SUBJECT: MOONEY 24 VOLT AIRCRAFT ELECTRICAL WIRING MODIFICATION,
(Revision A modifies basic S.B. instructions).

MODEL/S/N AFFECTED: MOONEY MODELS: M20J - S/N 24-3000 THRU 24-3122
M20K - S/N 25-1000 THRU 25-1213

FIGURE M20-245-1 (M20J and M20K only)

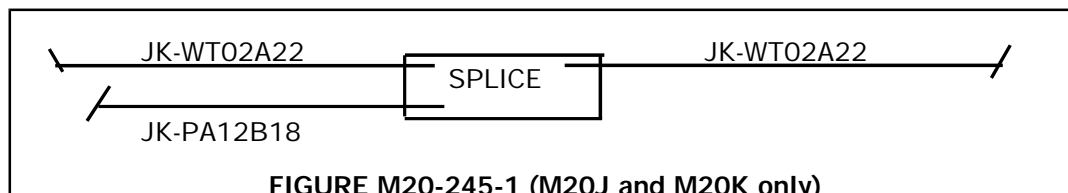
7. Locate wire number JK-WT02A22 connected to pin 1 of annunciator panel connector, JK-WT104A, and cut JK-WT02A22 wire approximately 6 inches back from connector.

8. Use AMP 320559 wire splice to re-connect wire number JK-WT02A22 and the unconnected end of new wire JK-PA12B18 (SEE FIGURE M20-245-1).
9. If **Dual Alternators** are installed, repeat Steps 1 through 5 with #2 regulator but on wire numbers JK-PA30A18 (Steps 1, 2 & 3) and JK-PA30C18 (Step 5). Route unconnected end of wire number JK-PA30C18 to vacuum switch on back of Artificial Horizon and connect to "white" terminal.
